# Access Compliance Report

## Public Rights-of-Way

### (Curb Ramps)

Intersection ID: 25859	Main Street: CARY_RIDGE_DR	Cross Street: CORRIGAN_CT	Location: SE
ADA ID: 5EE9914E9B1E	Ramp Type: PerpDiag	Initial Pass/Fail: Fail	Overall Compliance: No
Severity Score: 22.5			
Codes/Mitigation Info/Possible Solution		Field Measurements/Component Compliance

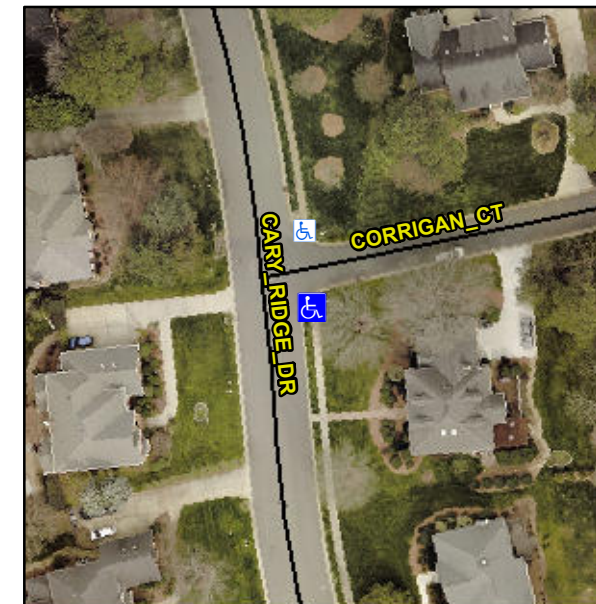
**Not Found, R304.5.1, R304.2.2, R304.5.3**

Compliance	Description	Data	Compliance	Description	Data
N/A	Ramp Length (in)	62.0	No	Ramp Slope (%)	9.7
No	Ramp Width (in)	39.0	No	Ramp XSlope (%)	2.1
N/A	Flare Type LT	N/A	N/A	Flare Type RT	N/A
N/A	Flare Slope LT (%)	N/A	N/A	Flare Slope RT (%)	N/A
N/A	Flare Traversable LT?	N/A	N/A	Flare Traversable RT?	N/A
N/A	Landing Length (in)	N/A	N/A	DWS Provided?	N/A
N/A	Landing Width (in)	N/A	N/A	DWS Contrast?	N/A
N/A	Landing Slope (%)	N/A	N/A	DWS Length (in)	N/A
N/A	Landing X Slope (%)	N/A	N/A	DWS Full Width?	N/A
N/A	Landing Curb? (Y/N)	N/A	N/A	DWS Offset (in)	N/A
N/A	Shared Landing?	N/A			
N/A	Gutter Ponding?	N/A	N/A	Gutter Slope (%)	N/A
N/A	Gutter Lip Ht (in)	N/A	N/A	Gutter X Slope (%)	N/A
N/A	Painted X Walk1?	No	N/A	Painted X Walk2?	No
	X Walk 1 Direction	To N		X Walk 2 Direction	To W
N/A	X Walk 1 Width (in)	N/A	N/A	X Walk 2 Width (in)	N/A
	X Walk 1 Slope (%)	0.2		X Walk 2 Slope (%)	6.7
	X Walk 1 X Slope (%)	3.2		X Walk 2 X Slope (%)	3.7

**Remove & Replace Curb Ramp With Two New Directional Ramps or Equivalent.**
